172-174 St. John St.

Warehouse Expansion

PLANNING REPORT #2-01

**WAREHOUSE AND STORAGE EXPANSION
SITE PLAN AND SITE LOCATION OF DEVELOPMENT REVIEW
REDLON JOHNSON, APPLICANTS**

PIPE TEES TO
TRAP FLOATNG CONTAMINANTS

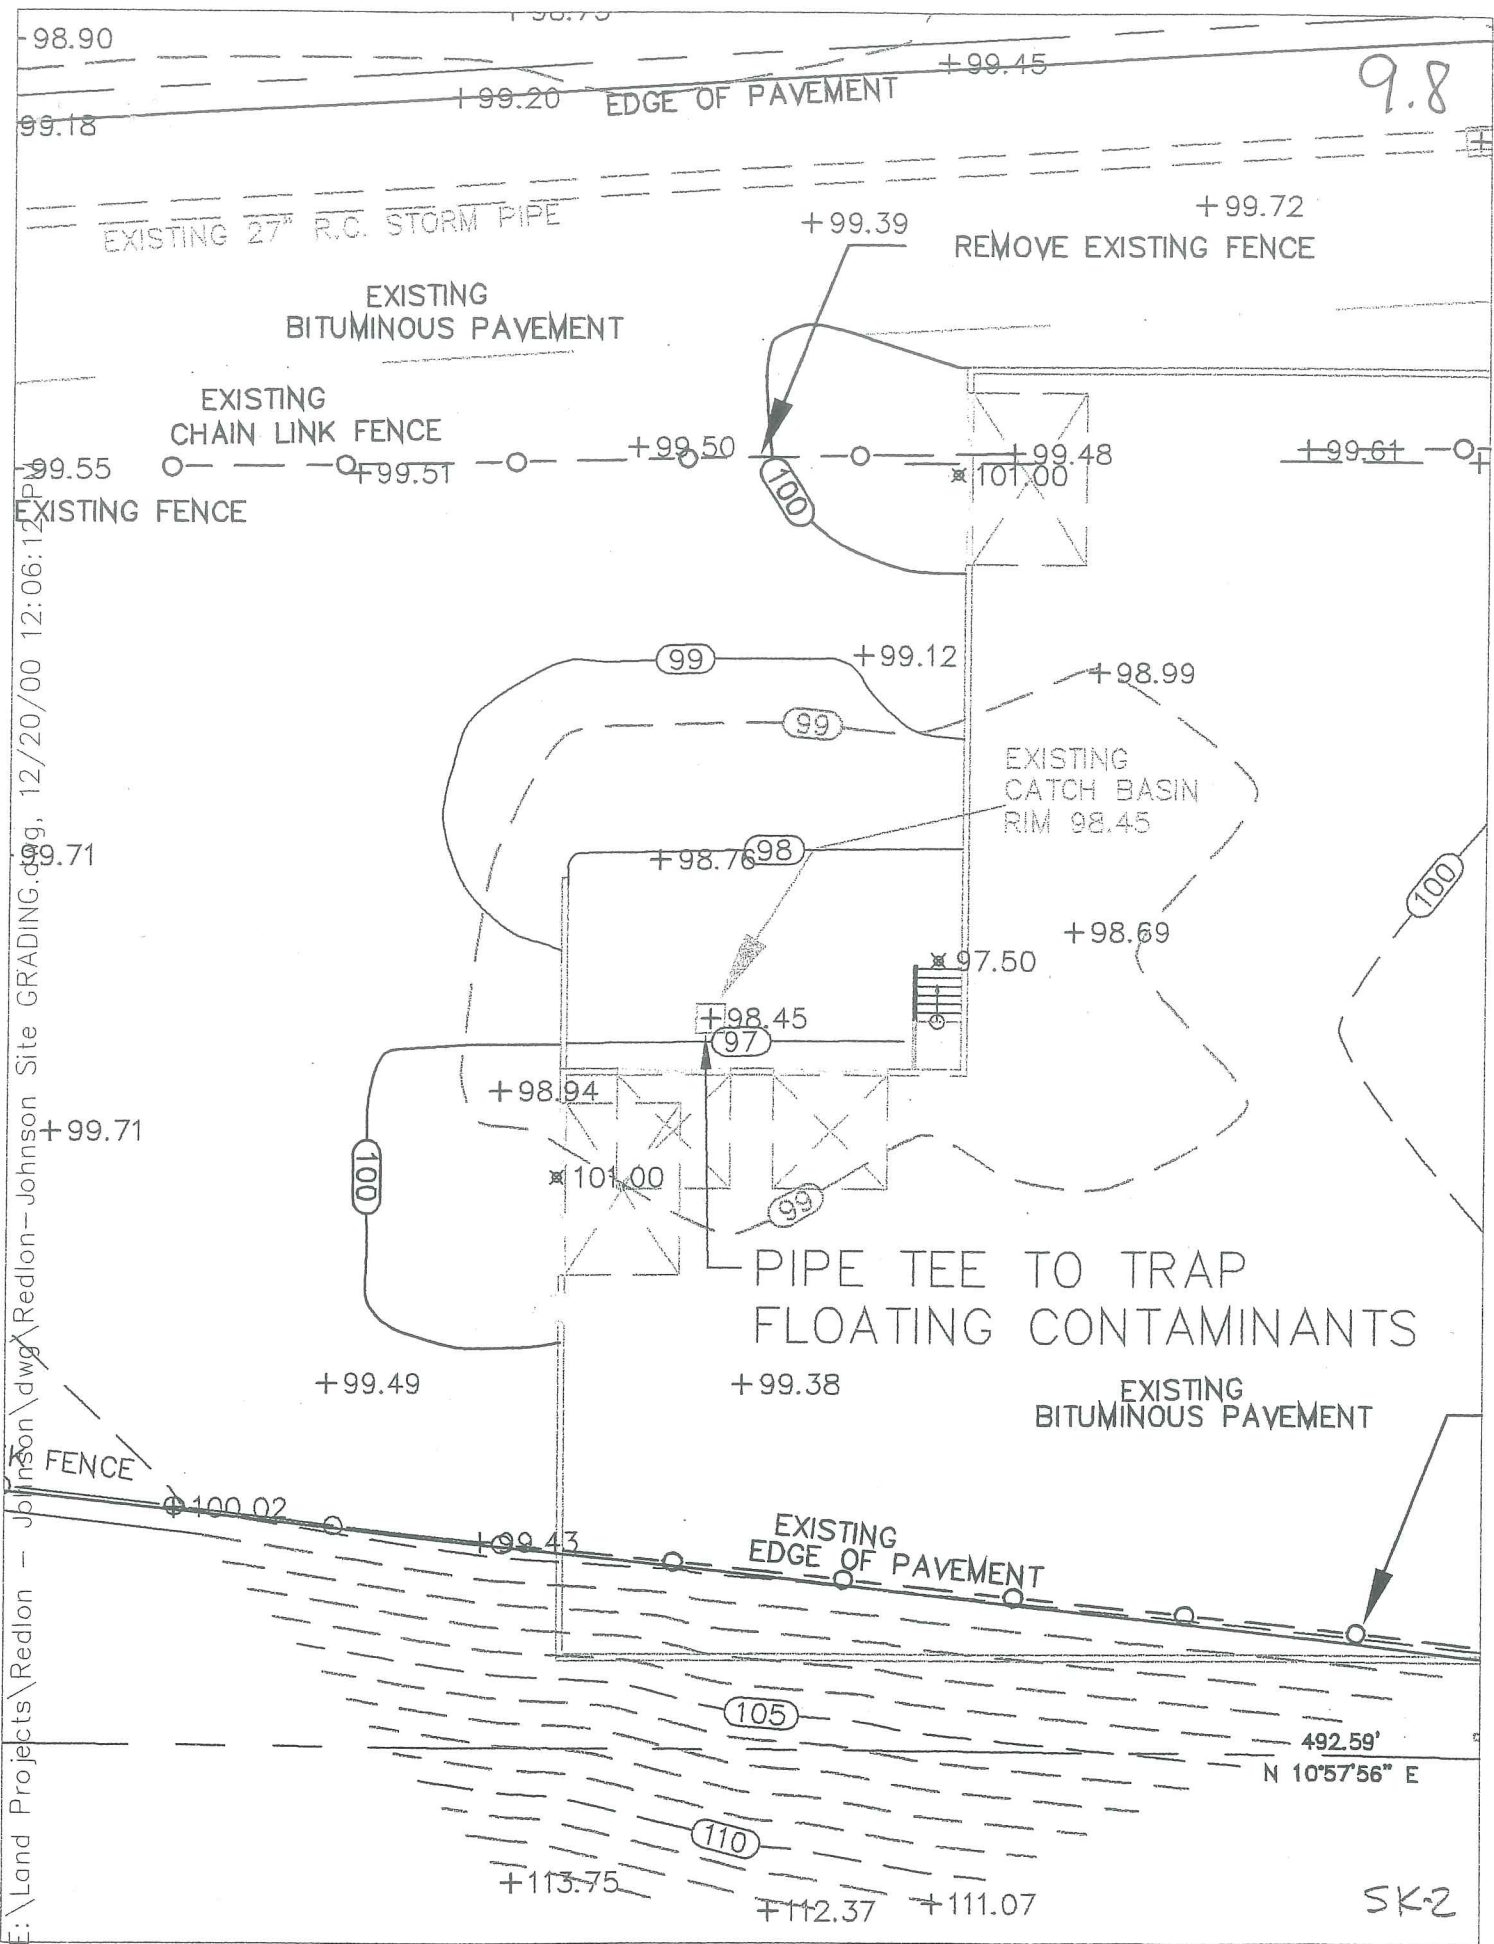
The applicant proposes to add a new catch basin near the addition, and will be outfitted with a gas hood. Additionally, in response to Planning Staff concerns for increased storm water treatment, the applicant has added "tee" outlets to the existing catch basins in the customer parking area to catch floatables and provide some TSS removal. See up-dated Stormwater Quality Report, Attachment #9. Planning Staff and DRC, Steve Bushy have concerns that more storm water treatment should be provided. See DRC memo dated January 5, 2001, Attachment #12.

The applicant bases their use of the modified catch basin approach for storm water treatment on (1) the fact that no quantified TSS removal rate is specified under the ordinance; and (2) the fact that the DEP no longer gives the Vortech-type structures a quantified rate of removal. Planning Staff recommends a higher level of stormwater treatment based on (1) the fact that both local and state standards require "no adverse impact" as part of larger scale development- regardless of Chapter 500 guidelines; and (2) the fact that, according to the DRC, the Vortech-type structures will provide greater treatment levels over the modified catch basin design.
